# **Christmas Creek Expansion Public Environmental Review – Response to Public Submissions**

**Christmas Creek**

**25 September 2015  
CC-RP-EN-0120**

Figure 5 – Expansion Proposal Potential Restricted Troglifauna Impacts

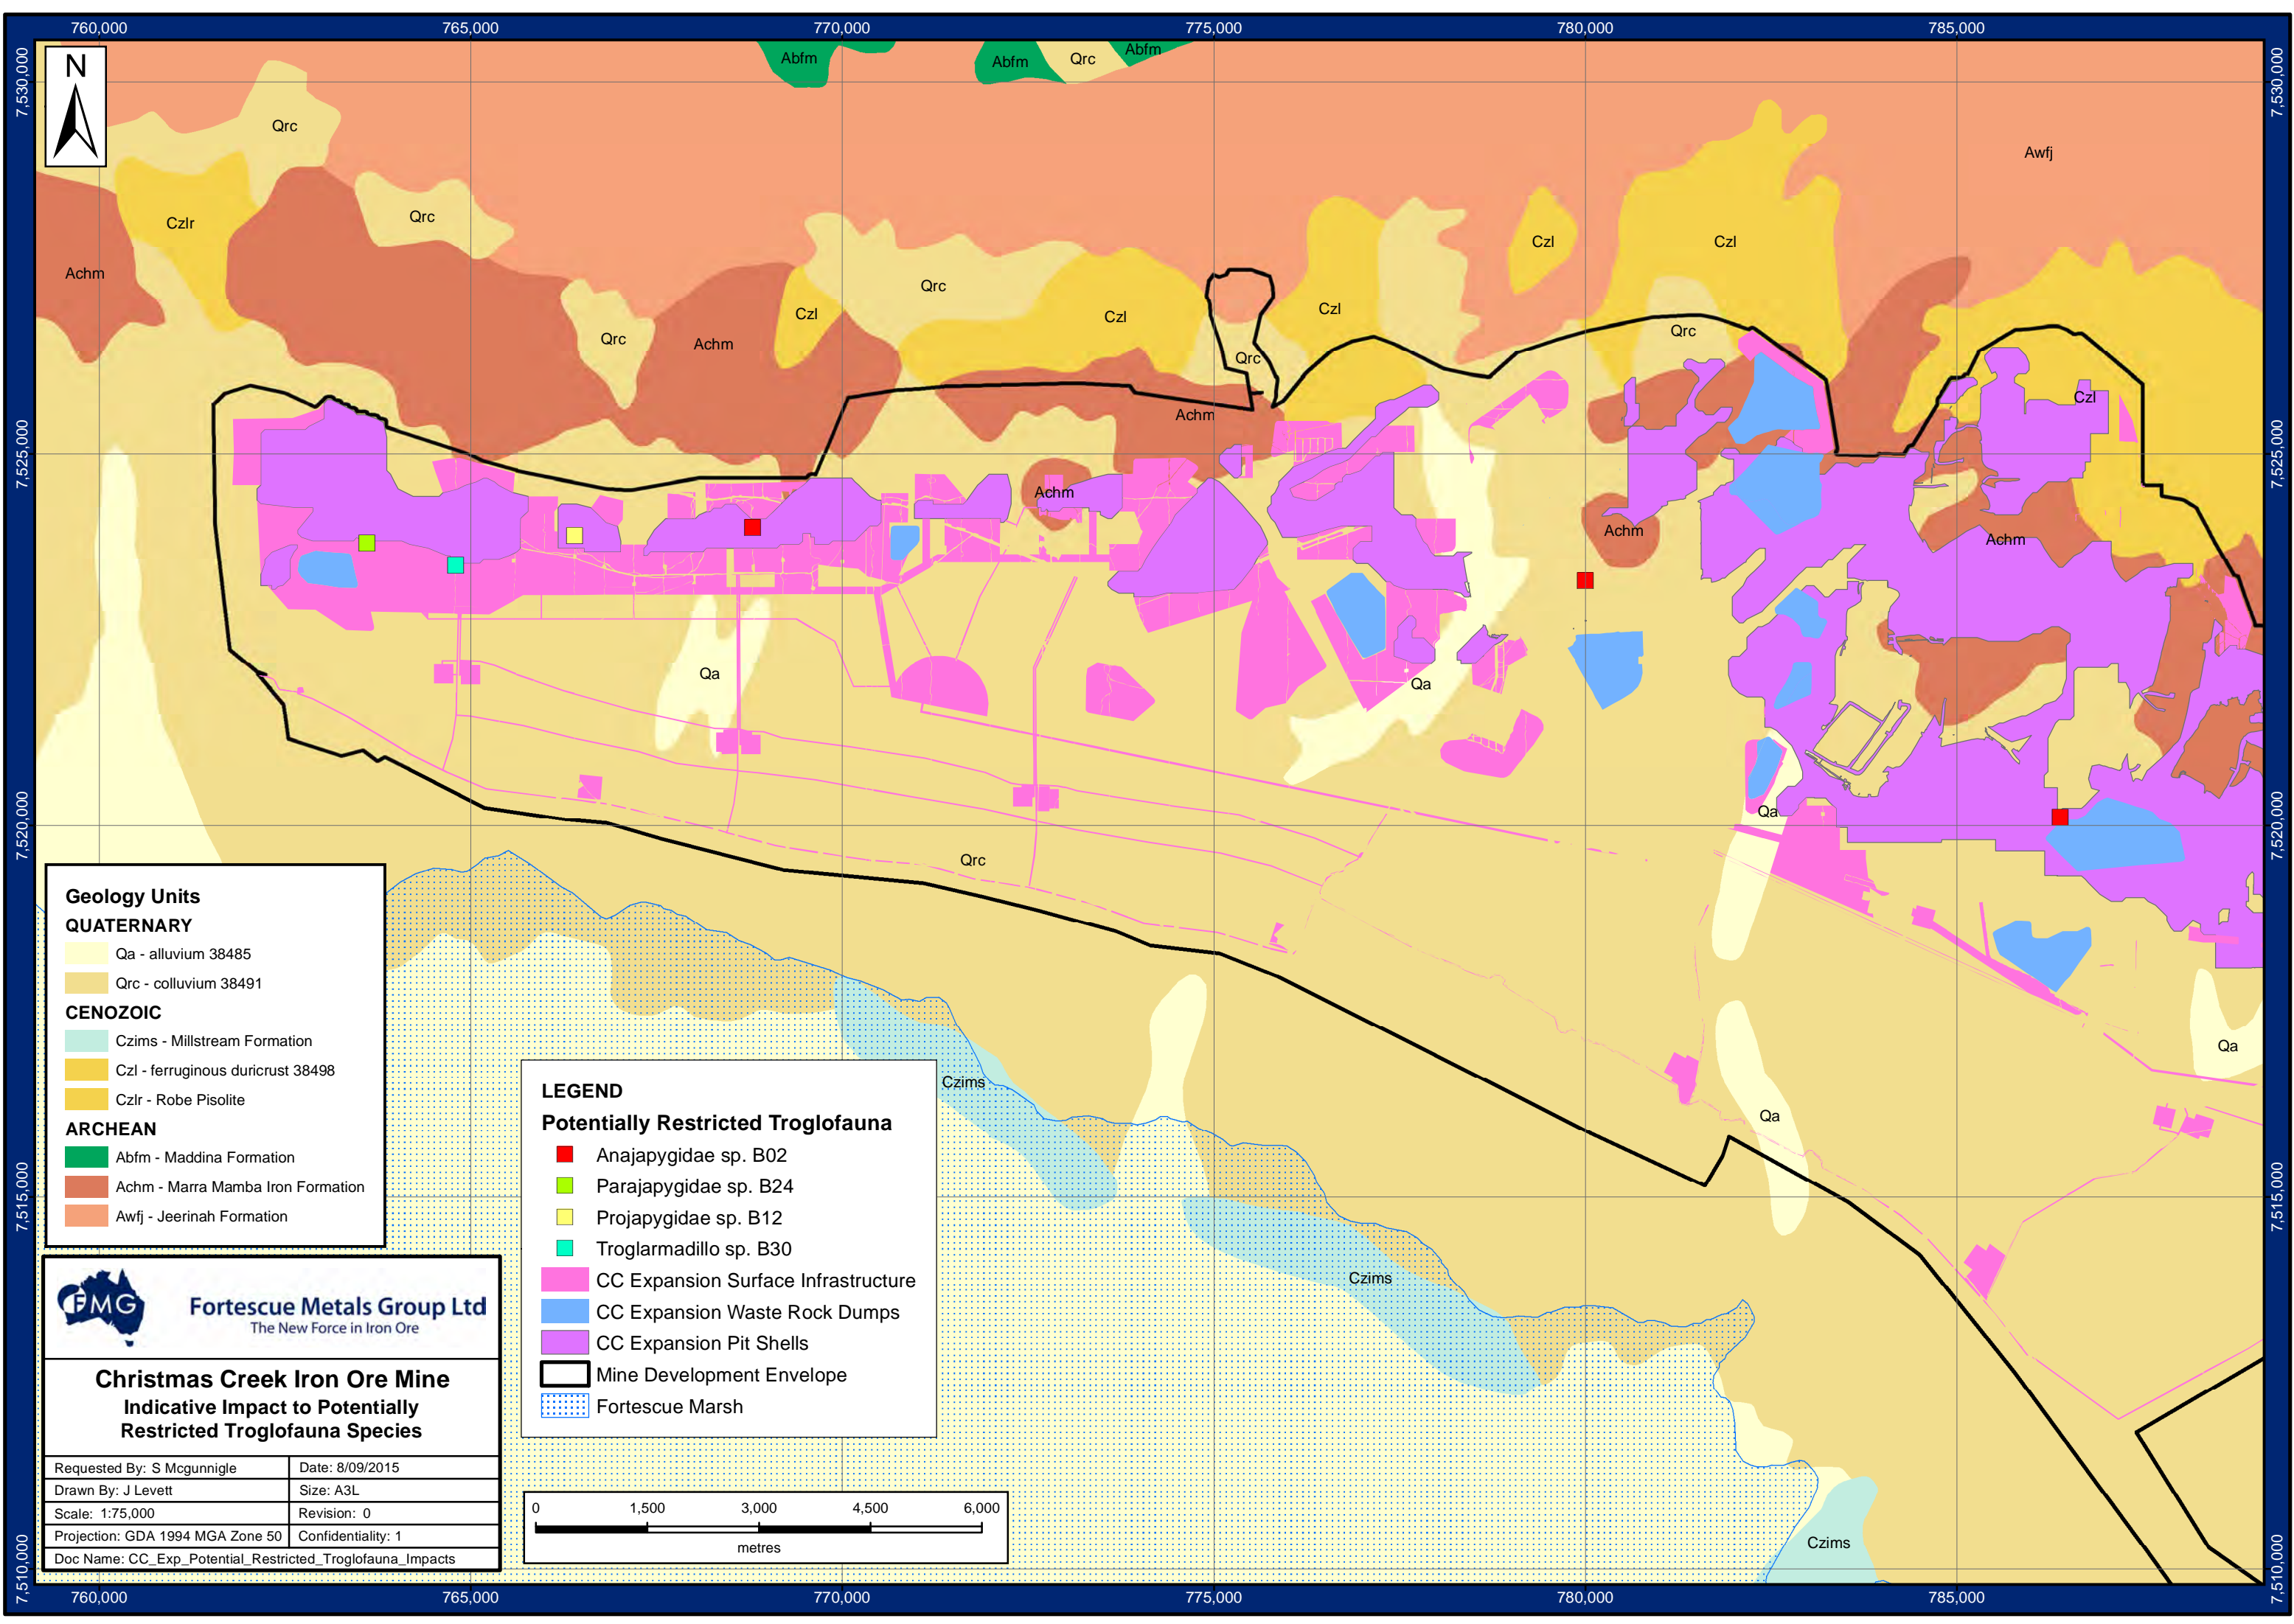
1.10	<p>In addition the statement that 'the proposal is not expected to represent an impact to subterranean fauna habitat from pit excavations and groundwater drawdown and mounding' (Table ES4) is not correct. Table ES4 lists impacts to nine subterranean fauna species: Five species of stygofauna are expected to be impacted from groundwater drawdown; two troglofauna species and expected to be affected by habitat loss resulting from pit excavation; and two species of troglofauna may be exposed to habitat loss from groundwater mounding.</p> <p>Options for minimisation strategies for the impacts to stygofauna (groundwater abstraction and injection) have been considered. Reducing the impacts to troglofauna through the loss of habitat from abstraction of ore and waste rock has not been considered (section 11.5 and 11.8). Options for the avoidance or minimisation of loss of subterranean fauna habitat of those species currently only known from the impact area should be included, until habitat connectivity has been confidently demonstrated.</p>	<p>The information provided in Table ES4 of the PER is consistent with the statement provided in Section 11.9 of the PER however there does appear to be some discrepancies. It appears Section 11.9 of the PER had been amended during production of the PER and the amendments not transferred to the relevant section of Table ES4.</p> <p>Fortescue concludes the statement of predicted outcomes to subterranean fauna species provided in Section 11.9 of the PER to be correct.</p> <p>Troglofauna habitat is widely distributed across the southern slopes of the Chichester Ranges. Surveys for troglofauna in the Chichester Ranges and along the southern slopes have been undertaken by Fortescue for a number of projects (Cloudbreak, Christmas Creek and Kutayi). Troglofauna specimens have been recovered from 233 locations distributed over 110 km in an east-west direction along the foot slopes of the Chichester Ranges. Figure 4 illustrates the distribution of troglofauna specimen locations and the geology of the region.</p> <p>The following geology types have been successful for recording troglofauna specimens:</p> <ul style="list-style-type: none"> <li>• Achm - Marra Mamba Iron Formation</li> <li>• Czl - ferruginous duricrust 38498</li> <li>• Qa - alluvium 38485</li> </ul>

Figure 6 – Expansion Proposal Troglafauna Distribution

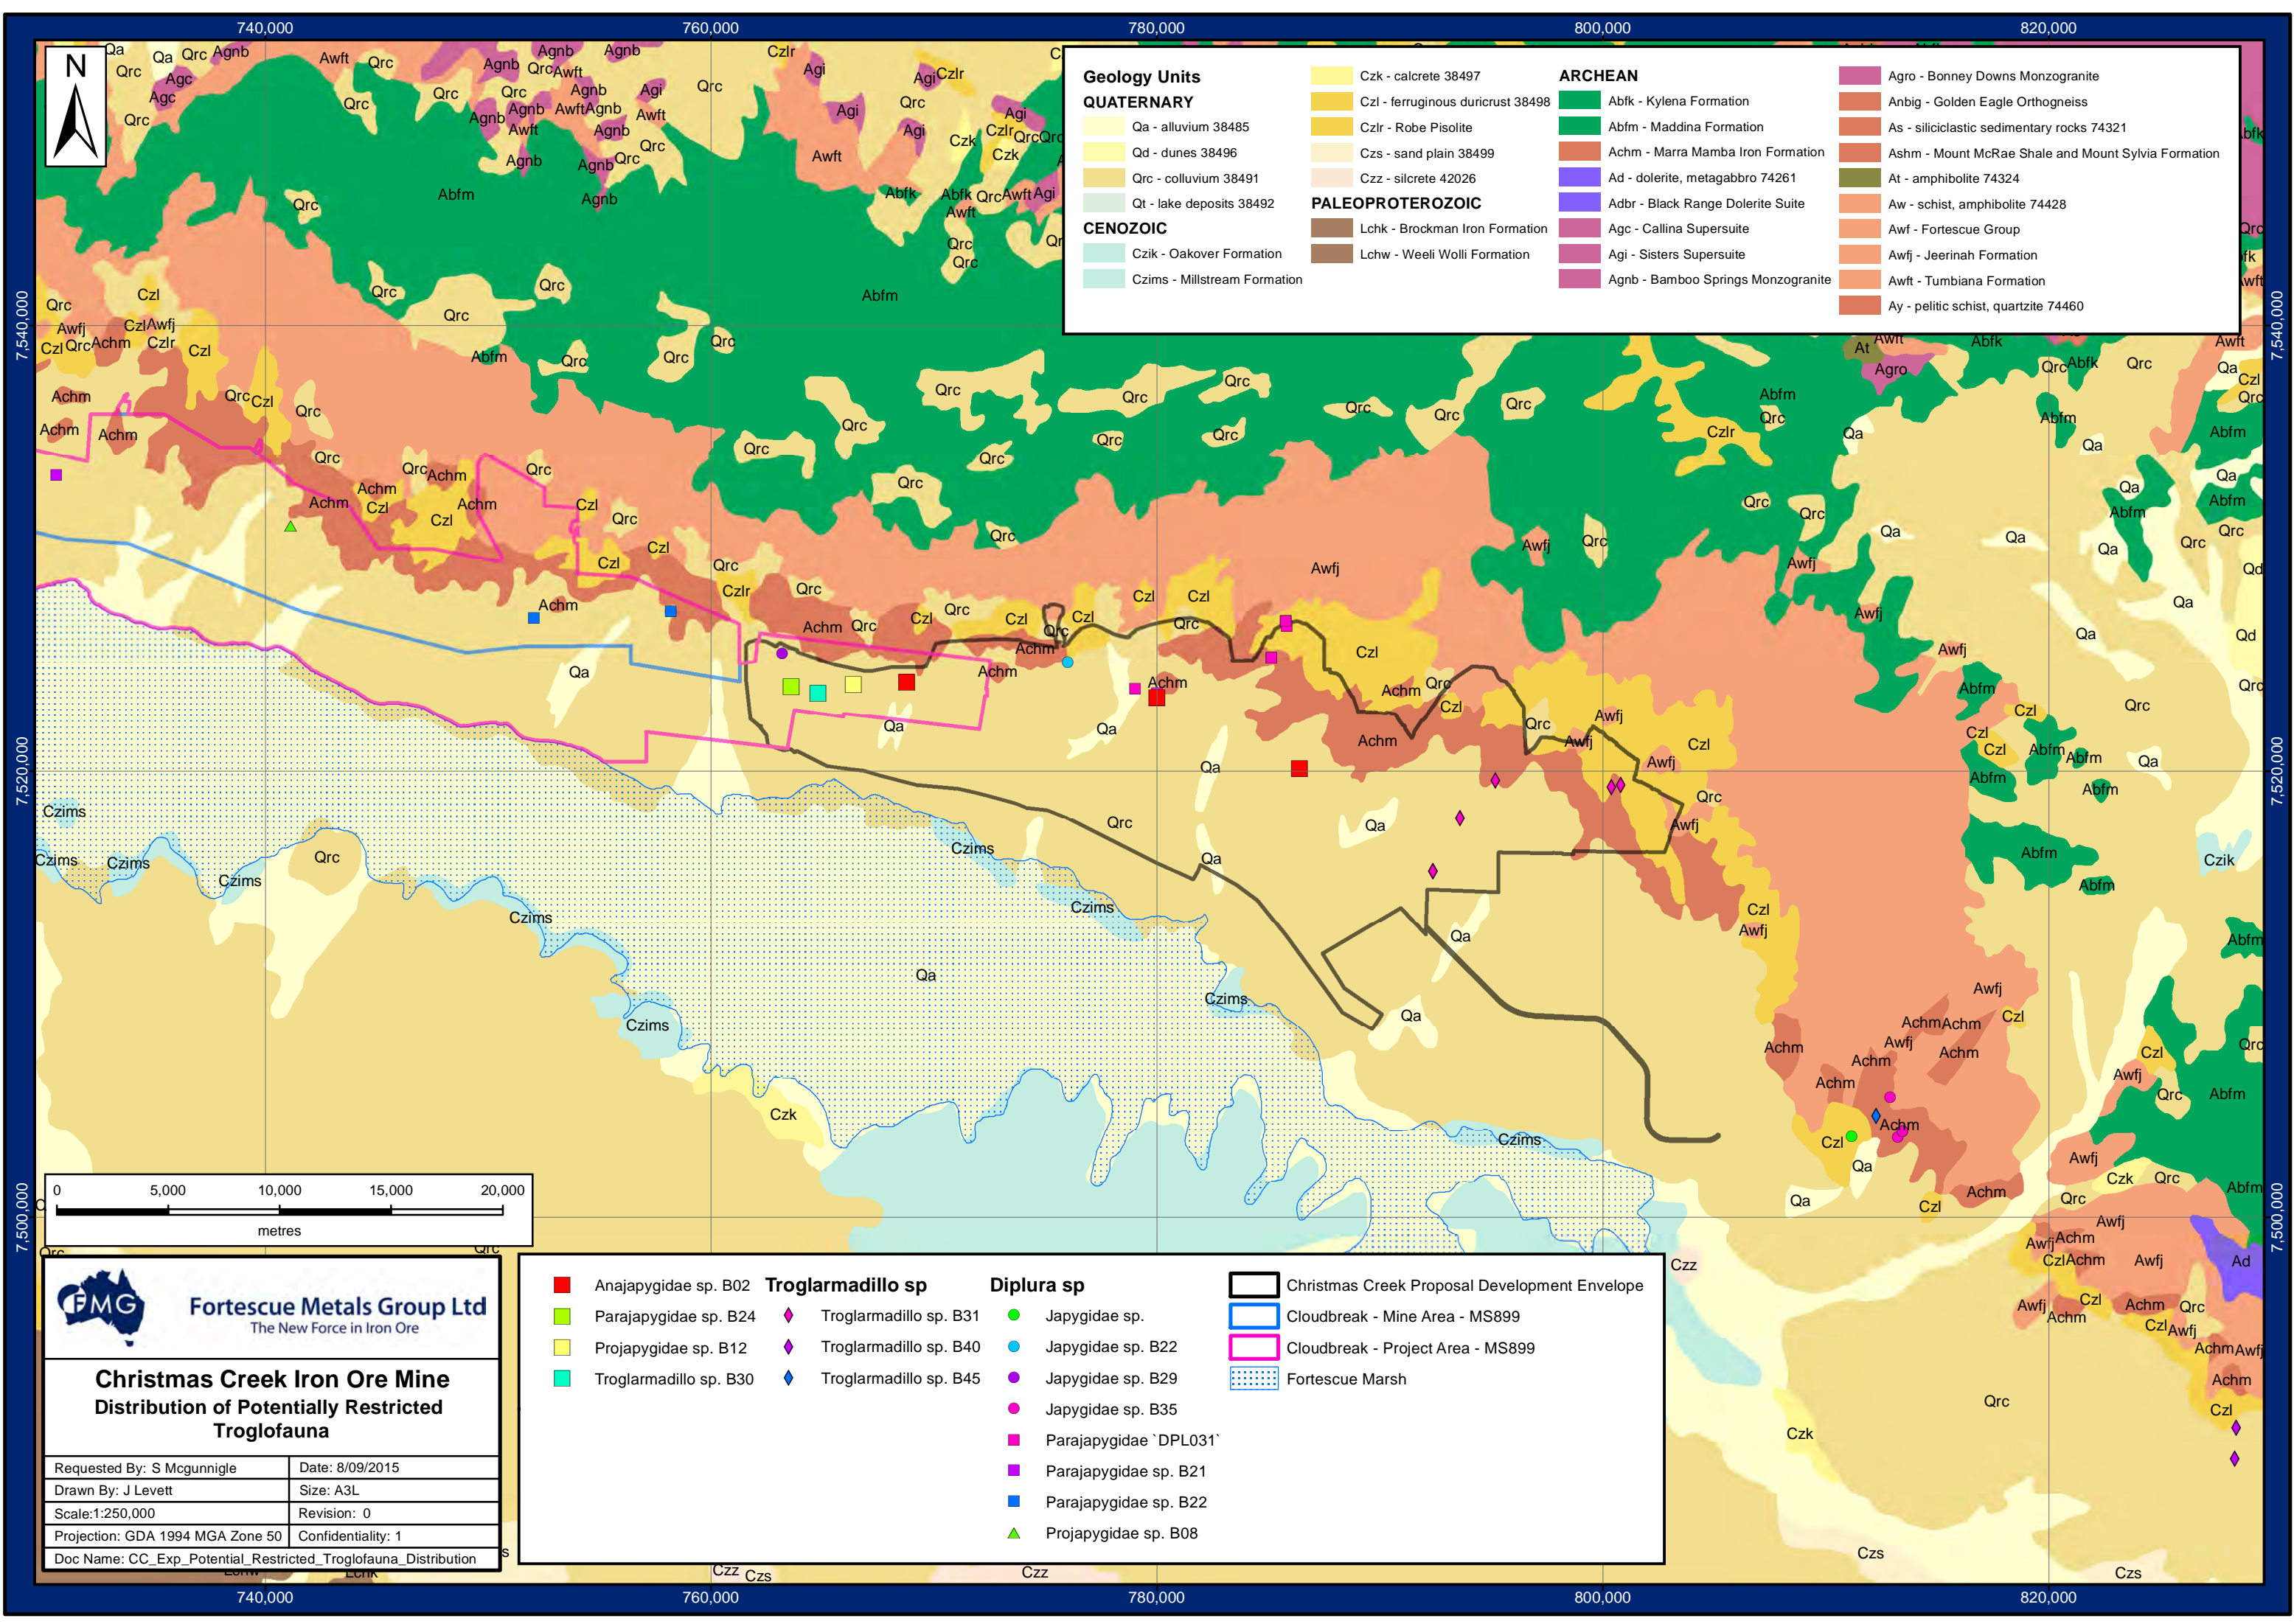
<b>Subterranean Fauna</b>		
1.8	<p>The PER makes contradictory statements regarding the connectivity of subterranean fauna habitat. Page 197 states that 'all troglofauna habitat within the proposal area are likely to be well connected'. However it goes on to state that 'sampling results seem to indicate that a series of 'barriers' occur along the northern flank of the Fortescue Marsh that restricts the ranges of several species'. Therefore, there is doubt regarding troglofauna habitat connectivity and consequently, the likelihood of the four troglofauna species being found outside of the impact area is uncertain. The proponent needs to verify these statements.</p>	<p>Further information in regards to troglofauna habitat and potential barriers is provided in section 7.12 of the PER Appendix 7D - <i>Christmas Creek Expansion Project Subterranean Fauna Assessment (Bennelongia Pty Ltd, 2014)</i>.</p> <p>The statement of page 197 of the PER reads in full <i>"Based on the scale at which geological information is available, all troglofauna habitats within the Proposal area are likely to be well connected with the surrounding habitats. In contrast, sampling results seem to indicate that a series of 'barriers' occur along the northern side of the Fortescue Valley that restrict the ranges of several species"</i>.</p> <p>Fortescue does not consider the statement contradictory. Rather the statement is summarising that the distribution of the geology in the area indicates the troglofauna habitats are well connected however the sampling results indicate that a series of 'barriers' may be present that limit the ranges of several species.</p> <p>Page 34 of Appendix 7D goes on to state <i>"The nature and exact location of these barriers are unknown and, in fact, there are probably different barriers affecting the distributions of different groups of troglofauna. For a species such as Philosciidae 'ISO017', which has a known range of 73 km along the valley (Figure 7.2), there may be no barriers"</i>.</p> <p>Appendix 7D concludes that the utilisation of geological data to characterise habitats has limited capacity to predict the extent of occurrence of troglofauna species along the Marsh.</p>
